## Authors' Response to Reviewer 1

## Authors' Response to Reviewer 2

“Figure 1: Distribution of the weather stations used in this study. (Line 205 in the clean version of the revised manuscript)”

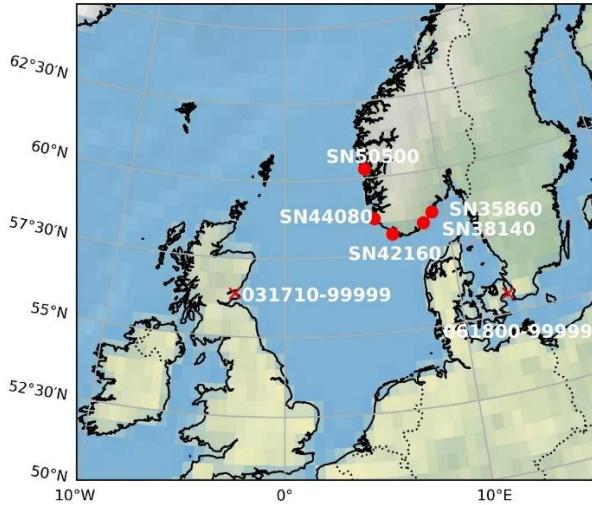
**Reviewer's Comment #2:** My comments regarding the revisions: The authors have quantified the levels of accuracy of using wind speed series of different lengths regarding estimates of various statistical parameters related to wind energy. The results are however - as they also state - limited to Southern Norway using coastal weather stations only. The authors invite more studies for other areas. Although not a request, it would have added extra value if it somehow had been included in this paper.

**Response to Comment #2:** Thank you for your thoughtful and constructive suggestion. We have extended our analysis by incorporating two additional coastal stations located outside Norway—one in Denmark and one in Scotland. These sites are situated in or near operational wind farms in the North Sea and thus serve as relevant and practical complements to our original Norwegian stations.

Both stations provide 46 years of hourly wind speed observations, allowing us to test the robustness of our findings in different geographical and climatological settings. Specifically, we used these longer and uninterrupted datasets to explore the differences between random and continuous sampling approaches, which also responds to related concerns in Comment #3. This additional analysis enhances the generalizability of our guidance on data length requirements for wind resource assessments.

To maintain the coherence of the manuscript structure, we have incorporated this complementary analysis into Section 4.1 of the Discussion. We also present the added contents as follows:

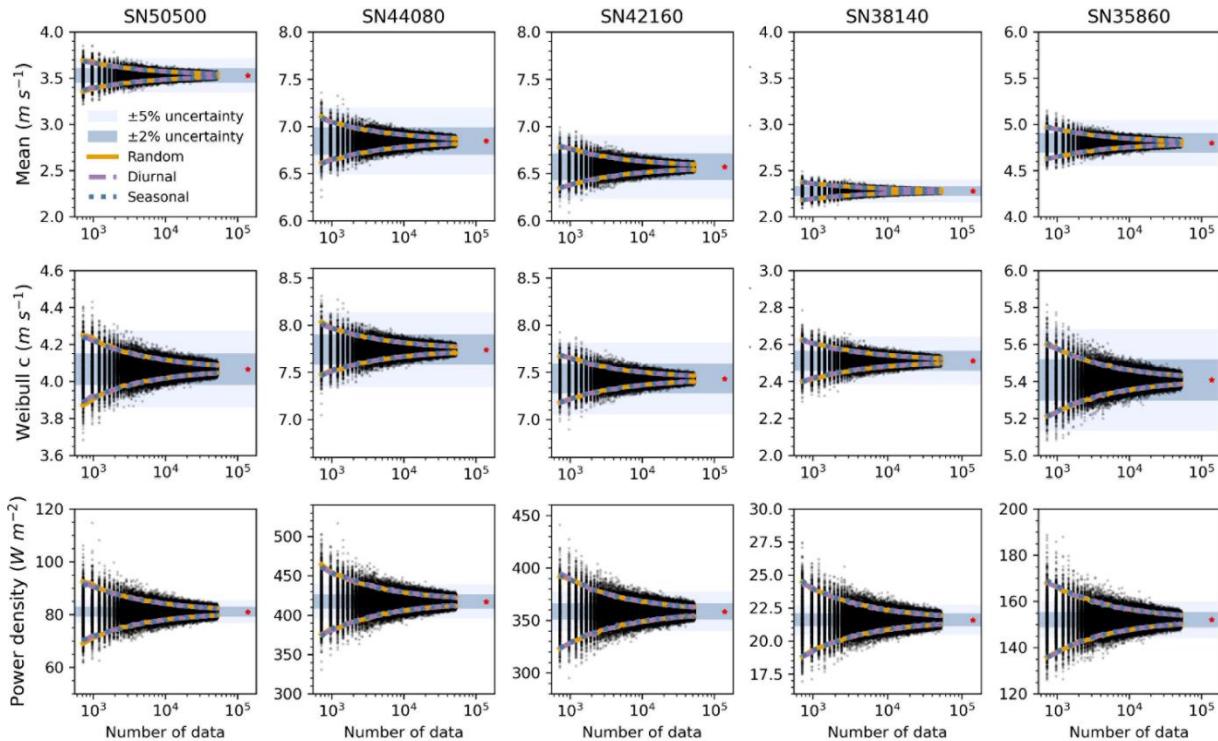
**Reviewer's Comment #6:** Page 8 and page 10 contain very detailed graphical illustrations of this point. They are however not easily grasped: 5 stations and 7 parameters giving 35 small plots. Even in a A4 print it is not a simple exercise to see every point discussed. Especially in figure 3 the blue colors are not easily identified.

Page 10, figure 3, contain an extra column with a1) - a6) superimposed on the middle column of small plots. Should be removed.

**Response to Comment #6:** Thank you for your valuable feedback regarding the visual clarity of the figures. In response, we have revised the figures to improve readability. Specifically, we retained only three key variables, mean wind speed, Weibull scale parameter ( $c$ ), and power density, for the five Norwegian stations in the main manuscript, and moved the remaining variables to the supplementary materials. In addition, we have adjusted the color scheme to enhance visual distinction, particularly addressing the issue raised about the blue tones in Figure 3. The superimposed column labels (a1)–(a6) previously shown in the middle column of Figure 3 have also been removed, as suggested. An example of the revised figure is shown below:

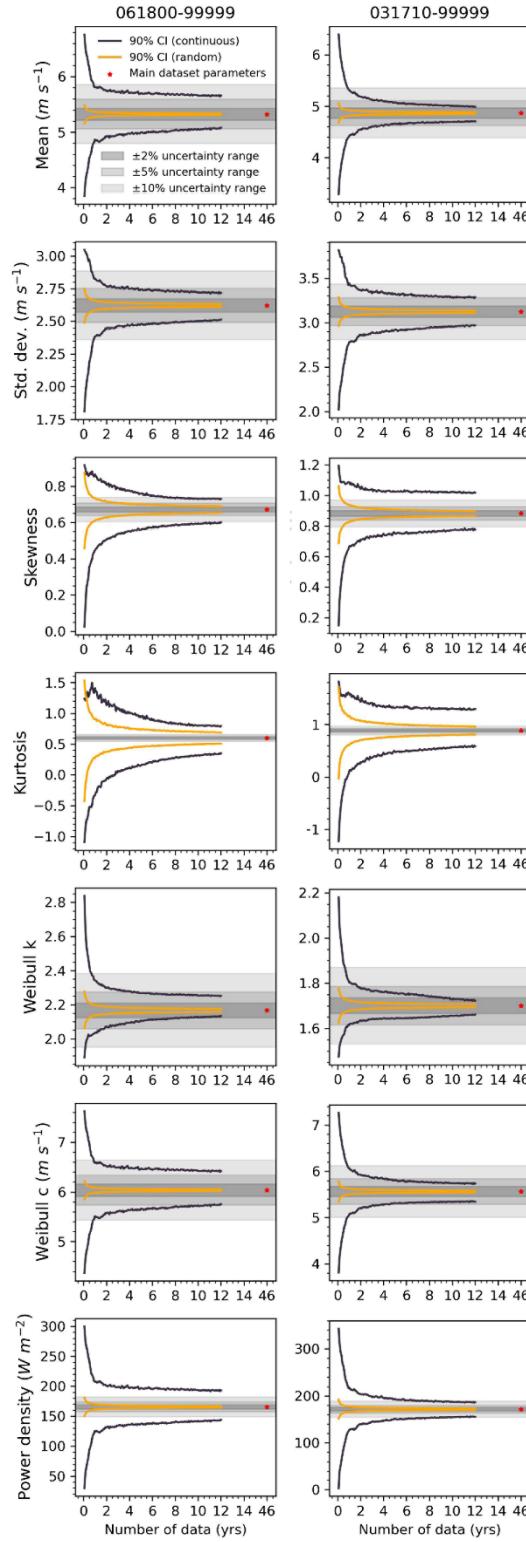
**Reviewer's Comment #3:** If there is some misunderstanding of the method on my side, please clarify the description of the method. If I have correctly understood the method, I would suggest two possibilities:

2. - Change the method to adapt it to the objectives. This could be done by selecting for example many different continuous datasets of the same length (e.g. 720 hour) within the full 16-year time series. The random sampling calculations already done could be retained for comparison purposes. A possibility to take advantage of the work already done, which is technically well performed, would be to use the results from the random sampling calculations to select the lengths of the continuous datasets to analyse. That is, not all lengths until 6 years would be analysed with continuous datasets, only lengths from 720 hours to a threshold determined from the errors obtained in the random sampling calculations.

**Response to Comment #3:** We sincerely thank the reviewer for the thoughtful and constructive suggestions. In response, we followed the second suggestion proposed by the reviewer, namely, adapting the method to better align with the original objectives, by incorporating additional analyses based on continuous sampling.

To implement this, we used two additional stations located in Denmark and Scotland, each with 46 years of hourly wind speed observations, which allowed for sufficiently long and uninterrupted time series required for continuous sampling. The five Norwegian stations originally used in the study contain substantial data gaps and were therefore unsuitable for this type of analysis. Another reason for selecting these two additional stations is their geographical relevance: both are situated along the coast in the North Sea region, which is consistent with the coastal characteristics of the Norwegian stations.

The results of this additional analysis indicate that continuous sampling generally requires significantly longer time periods to achieve the same level of uncertainty in estimated distribution parameters, compared to random sampling. These findings reinforce the practical utility of random sampling when long, uninterrupted records are not available. Details of the comparison between

*Our results show that continuous sampling generally requires significantly longer periods to achieve the same level of uncertainty in estimated distribution parameters compared to random sampling (Fig. 7). This discrepancy arises because random sampling draws from multiple years, thereby capturing a wider range of interannual variability and reducing exposure to temporal clustering. Consequently, the 90% confidence intervals (CIs) under random sampling are symmetric for all parameters, while under continuous sampling, only the CIs for mean wind speed, Weibull scale parameter, and power density are symmetric. Shape-sensitive parameters, including standard deviation, skewness, kurtosis, and especially the Weibull shape parameter, exhibit pronounced asymmetries under continuous sampling, particularly at short durations (<2 years). This suggests that the presence of systematic climatic anomalies in continuous subsets may bias shape estimation.*

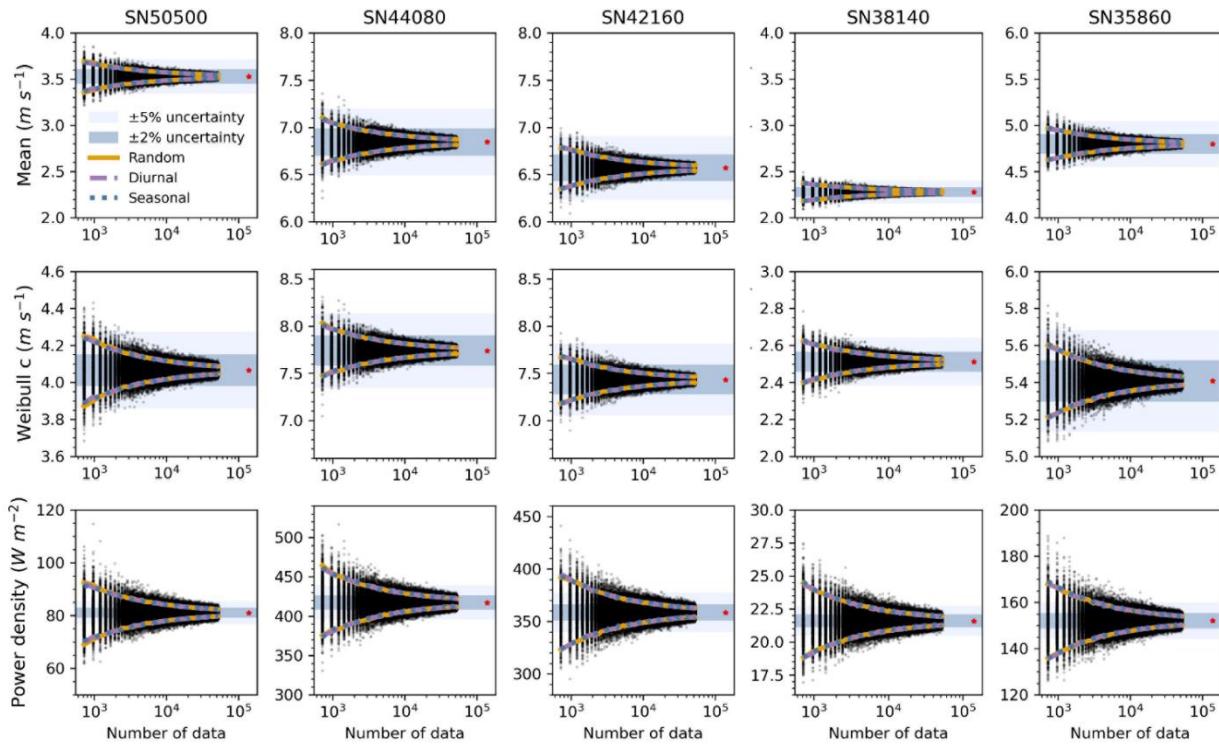
**Reviewer's Comment #4:** A minor point that could be improved is the presentation of the results are the figures. There are too many frames in every figure that make it difficult to see the most relevant results. A selection of a couple of meteorological stations, that are representative of the whole set of stations, could perhaps be done. The full graphs could be moved to the supplementary information section. Also, the 3 curves limiting the 90% confidence intervals are difficult to distinguish, as they largely overlap.

**Response to Comment #4:** Thank you for this helpful suggestion. This issue was also raised by Reviewer #1, and we have made corresponding revisions in the manuscript. Specifically, we now present only three key variables—mean wind speed, Weibull scale parameter ( $c$ ), and power density. The remaining variables have been moved to the Supplementary Materials to reduce visual clutter and enhance readability. We also revised the color scheme and line styles to improve the visual distinction of the 90% confidence interval curves, which previously overlapped and were difficult to differentiate. An example of the revised figure is provided below, as it appears in the revised manuscript.
